# Strategic reserve for winter 2017-2018:

Answer to the public consultation on methodology, hypotheses and data sources

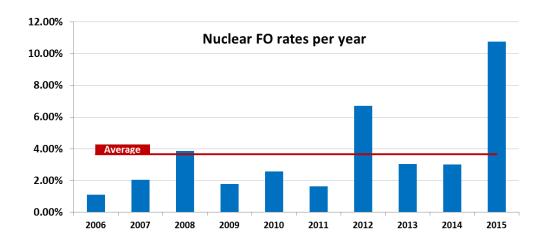
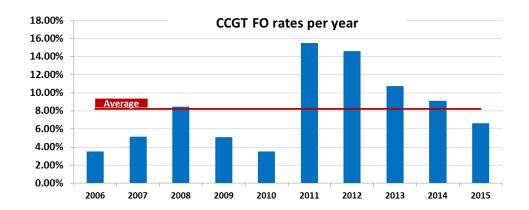
FEBEG is of the opinion that the unplanned unavailabilities should be reviewed and based on more recent figures: FEBEG is not convinced that historical data of before 2014 best reflect the current availability ratio of the units. [FEBEG]

The assumptions are also very similar to those taken for the previous report. Our main comment which was already made last year regards the availability (forced outage risk) of the thermal power units (4.2.2) As was the case last year the assumption is based on the average past availability and does not take into account the rise of unavailability that is visible in the historic data and confirmed by Eurelectric (see past replies for link to the actual study). Not only is this not included in the base case it is not even one of the sensibilities evaluated. [Restore]

Forced outages are mainly caused by technical failures. Analyzing the data for thermal units in Belgium, one can construct the following charts for nuclear and CCGTs in Belgium. Those charts show the yearly forced outage rates for those 2 types of units.

Note that only during 3 years the forced outages of nuclear units were above average (2008 – slightly above, 2012 and 2015). Removing the exceptional years 2012 and 2015, there is no clear trend of increased FO rates of nuclear units. Given the high FO rate observed in 2015, Elia proposes to use the average of the past 10 years (2006-2015) as reference and to make a sensitivity analysis on this assumption using the 2015 FO rate.

Concerning the CCGTs (see chart below) the FO rate in 2015 was under the average and a decreasing trend is observed since 2011. It is important to mention that the FO rates are calculated on the units in the market (strategic reserve units are thus excluded).
